**METROPOLITAN GOVERNMENT OF NASHVILLE AND DAVIDSON COUNTY**

**STAFF RECOMMENDATION**

**1410 Gale Lane**

**Application:** New construction—outbuilding; Setback Reduction

**SCHEMATIC SITE PLAN**  
SCALE: 1" = 20'-0"

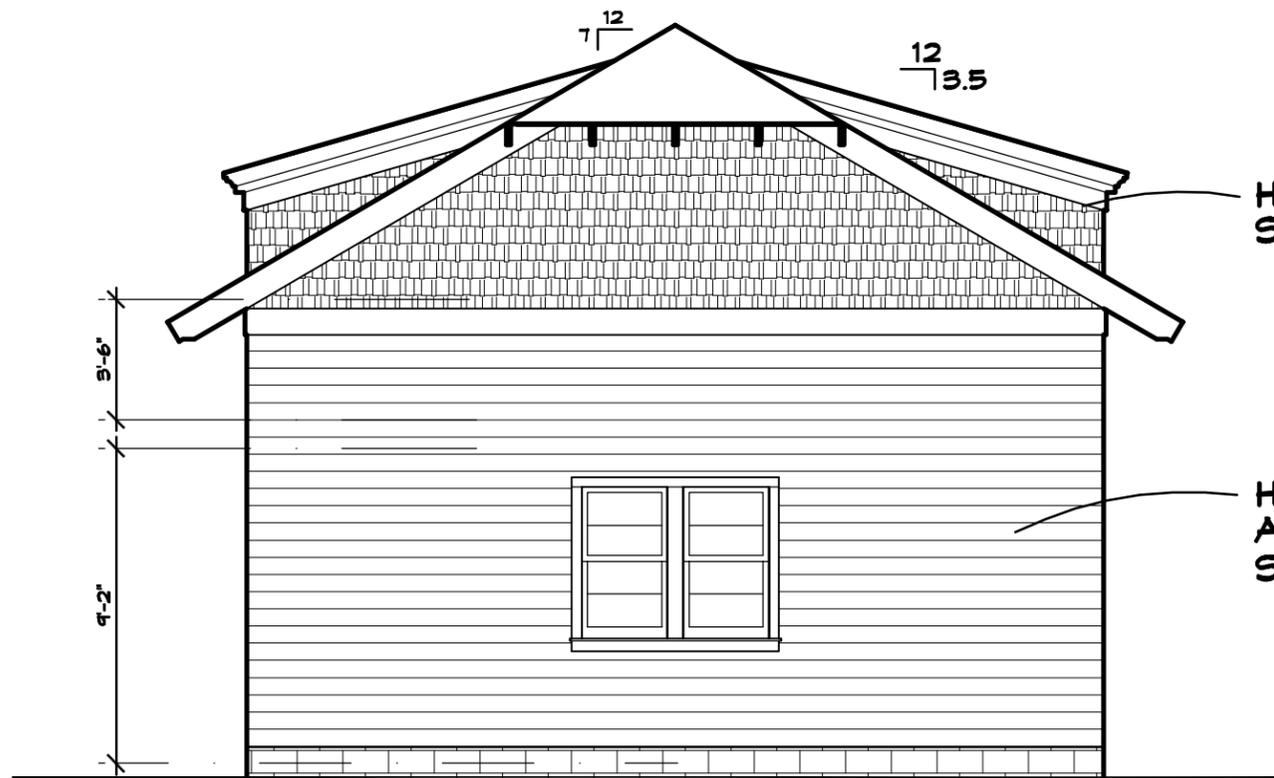
MHZC Note:  
Application is for  
garage only.

MHZC Note:  
Addition approved  
by MHZC in  
December and is  
not part of this  
application.

**RIGHT GARAGE ELEVATION**

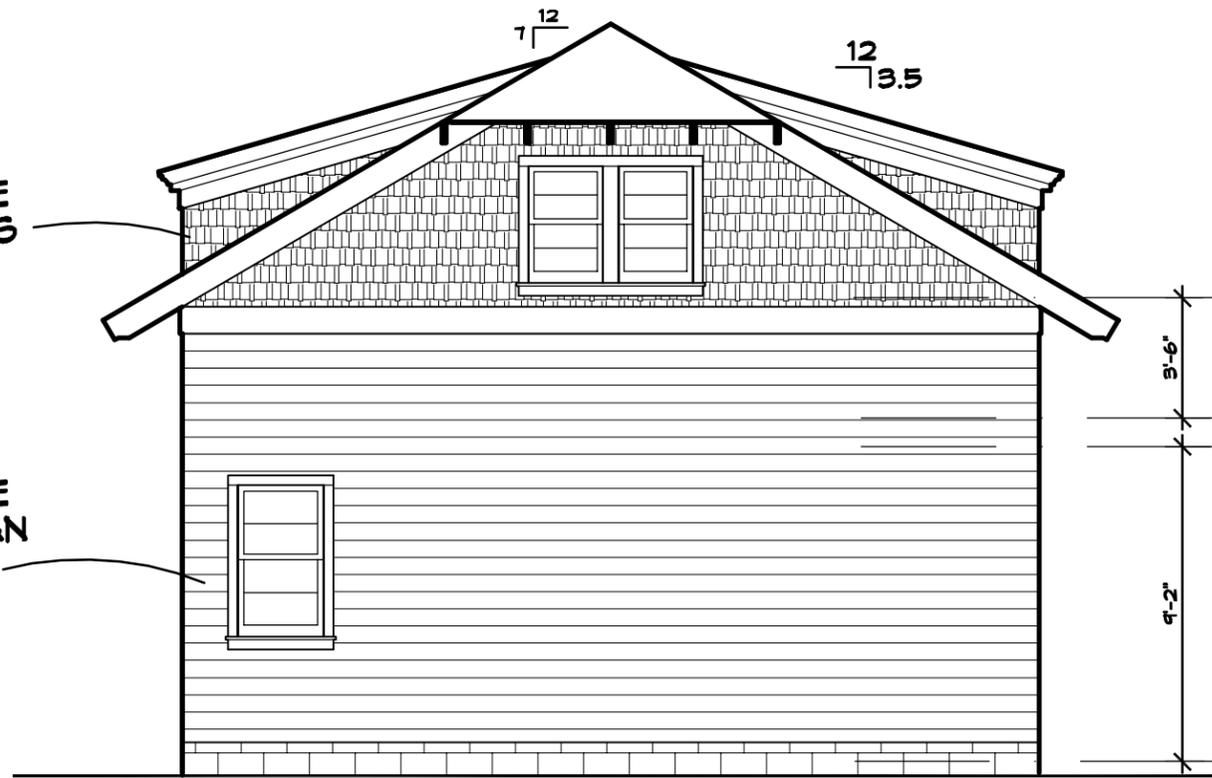
Materials, Texture, and Details and Material Color: The accessory structure will be primarily clad in cement fiberboard with a five inch (5") reveal. A shake material is proposed in the gable fields and in the dormers, and staff asks to review that material prior to purchase and installation. The roof will be three dimensional asphalt shingles in a dark gray color. Staff asks to approve the final color prior to purchase and installation. The materials for the windows and doors were not specified, and staff asks to review and approve all window and door specifications. With the staff's final approval of the shake, windows, doors, and asphalt shingle color, staff finds the materials for the proposed accessory structure to meet Section II.B.1.d. and II.B.1.i. of the *Belmont-Hillsboro Neighborhood Conservation Zoning Overlay: Handbook and Design Guidelines*.

**Recommendation Summary:** Staff recommends approval of the project with the condition that staff approve the shake material, window and door specifications, and the asphalt shingle color. With this condition staff finds that the application meets Section II.B.1. of the *Belmont-Hillsboro Neighborhood Conservation Zoning Overlay: Handbook and Design Guidelines*.
